# SERVICE BULLETIN

**Service Bulletin No.:** DAC1-24-04 Rev 3

**Title:** Generator Attachment Bracket

**Figure 1 - Mounting Bracket - Looking Inboard**

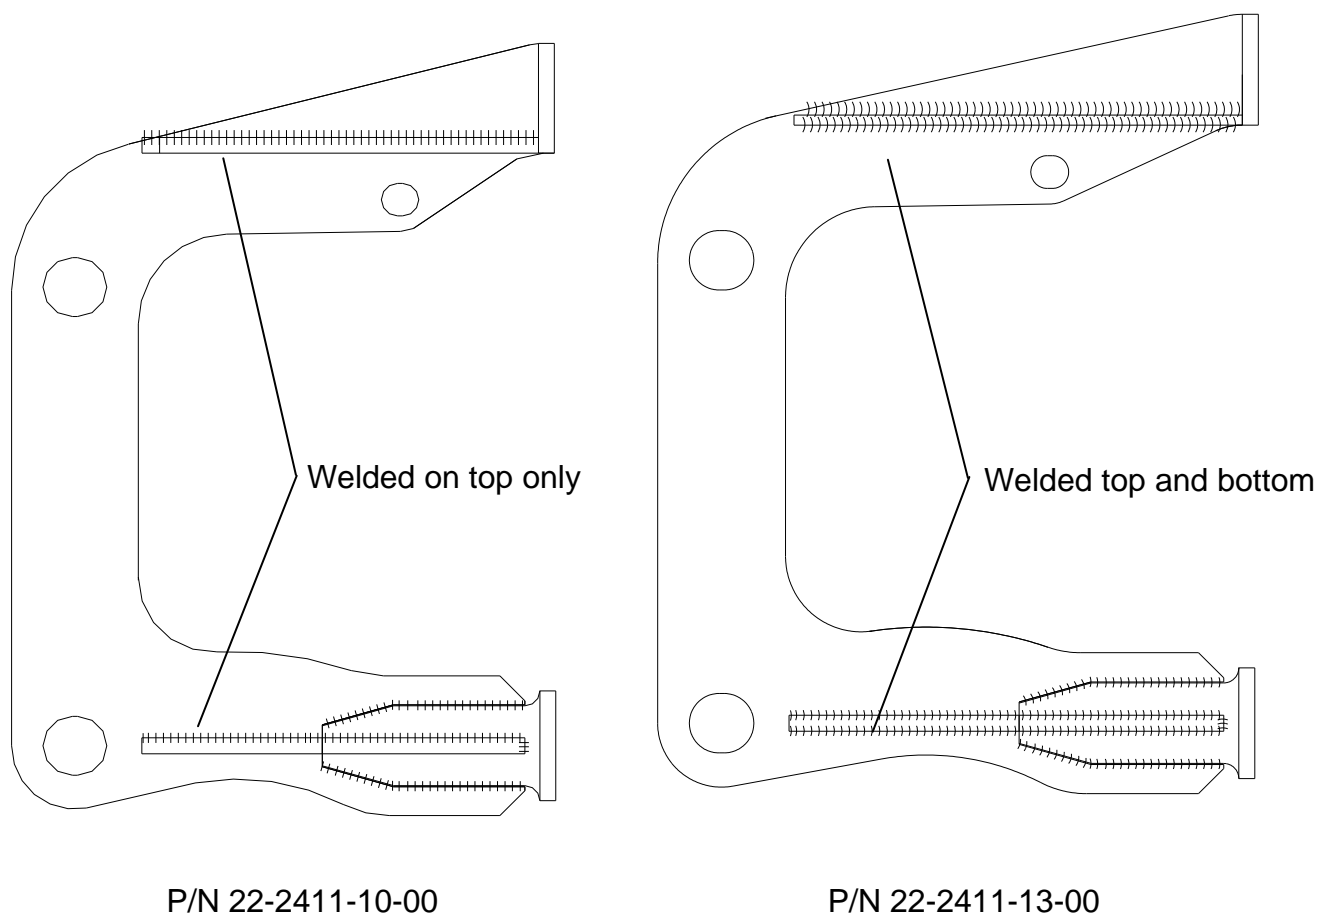
- 10.1** Identify which generator mounting bracket is installed. Figure 1 shows identifying details of generator mounting brackets P/N 22-2411-10-00 and P/N 22-2411-13-00.

If P/N 22-2411-10-00 is installed, installation of kit DAC1-24-04-AMK0 is required. Perform steps **10.2** through **10.22** of this Service Bulletin.

If P/N 22-2411-13-00 is installed, no replacement is required. Make a log book entry that this Service Bulletin has been incorporated.

Figure 2 - Replacement of the Generator Mounting Bracket

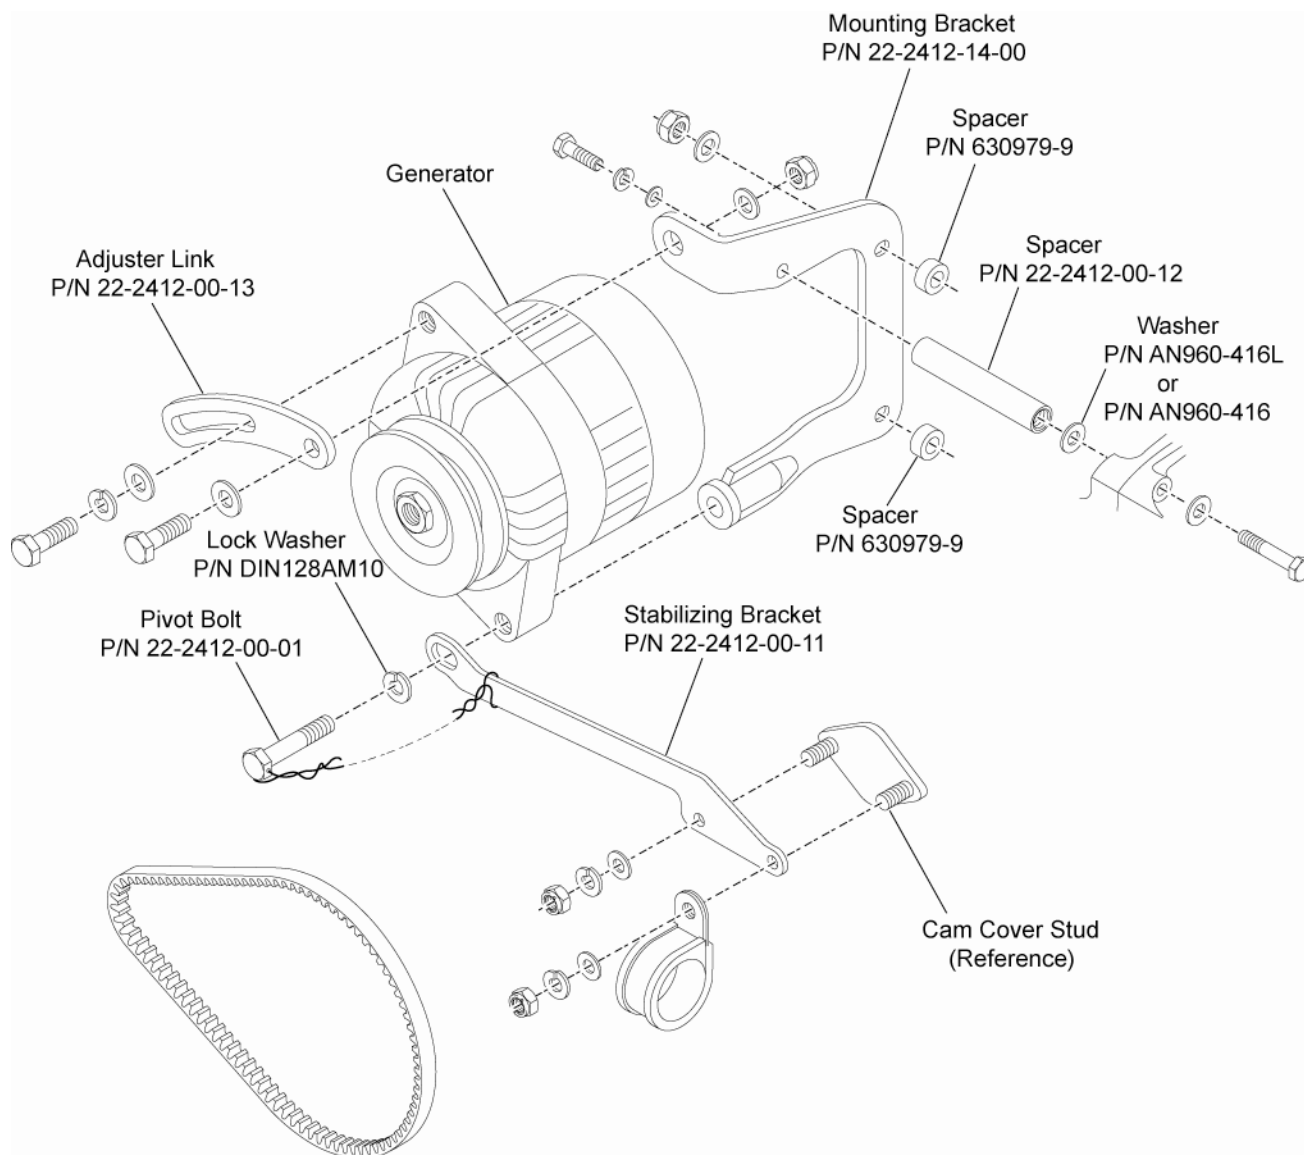
- 10.2** Remove the Generator (Refer to the MM, Chapter 24-30-00).  
Reference: Figure 2 of this Service Bulletin.
- 10.3** Remove and discard the lower mounting Pivot Bolt and Lockwasher.

- 10.4** Remove and discard the Stabilizing Bracket.
- 10.5** Remove and discard the Adjuster Link.
- 10.6** Remove and discard the Mounting Bracket.
- 10.7** Remove and discard the Spacer.

- 10.8** At the top forward side of the mounting bracket install the Washer (P/N AN960-416L or P/N AN960-416 are permitted) on the engine side of the through-bolt. Install the new Spacer (P/N 22-2412-00-12).

- 10.9** Torque the bolt going into the Spacer from the engine side to 11.3-14.0 Nm (100 – 125 in lbs).
- 10.10** Put the new Mounting Bracket (P/N 22-2412-14-00) loosely in place on the engine.

- 10.11** At the lower pivot point of the mounting bracket, install the Spacer (P/N 630979-9) on the through-bolt between the bracket and the engine. Lubricate the through-bolt with clean 50-weight oil. Install the nut and plain washer at the lower pivot point. Tighten, but do not torque the nut at this time because the mounting bracket will have to be adjusted.

- 10.12** At the upper pivot point of the mounting bracket, install the Spacer (P/N 630979-9) on the through-bolt between the bracket and the engine. Lubricate the through-bolt with clean 50-weight oil. Install the nut and plain washer at the upper pivot point. Tighten, but do not torque the nut at this time because the mounting bracket will have to be adjusted.

- 10.13** At the top forward side of the mounting bracket, going into the Spacer (P/N 22-2412-00-12), install the bolt, the plain washer and a new lock washer. Apply Loctite 222 to the threads of the AN4 bolt. Tighten, but do not torque the nut at this time.

- 10.14** Install the new Adjuster Link (P/N 22-2412-00-13) hand tight with the upper mounting hardware.
- 10.15** Trim the Apron Baffle as required to provide 1/8" nominal clearance around the new Stabilizing Bracket. Lightly sand the trimmed edges of the apron to remove roughness.

- 10.16** Install the new Stabilizing Bracket (P/N 22-2412-00-11). Install new lock washers. Lubricate the cam cover studs with 50 weight engine oil. Torque the nuts to 10.2-12.5 Nm (90-110 in lbs).

Figure 3 – Generator Alignment

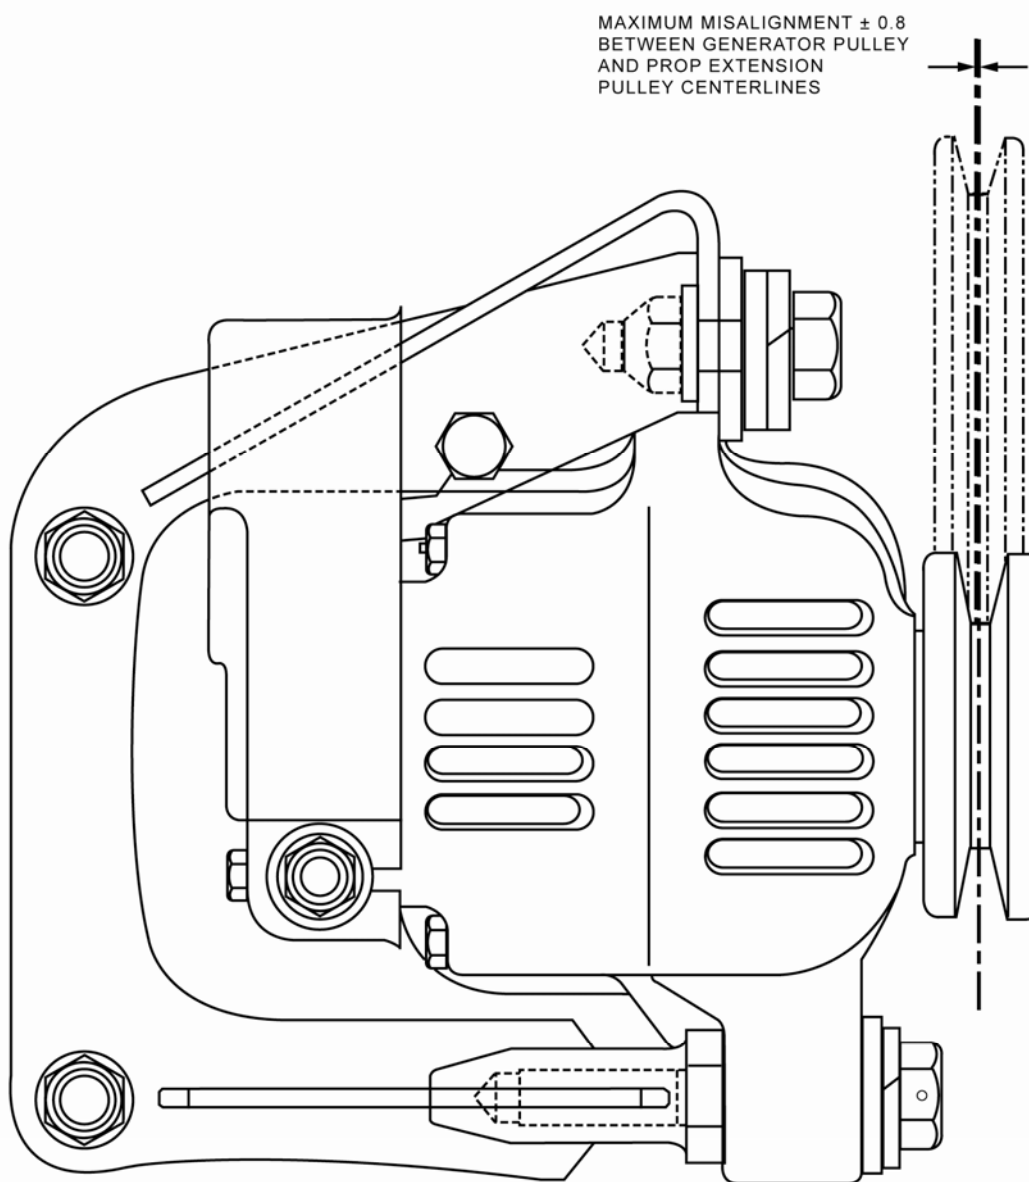
- 10.17** Put the Generator in place for a trial fit. Make sure that the generator pulley and the prop extension pulley can be aligned. Adjust the mounting bracket as necessary. The misalignment between the generator pulley and the prop extension pulley is not to exceed  $\pm 0.8$  mm (0.031 in). Refer to Figure 3.  
Remove the Generator from the trial fit position.
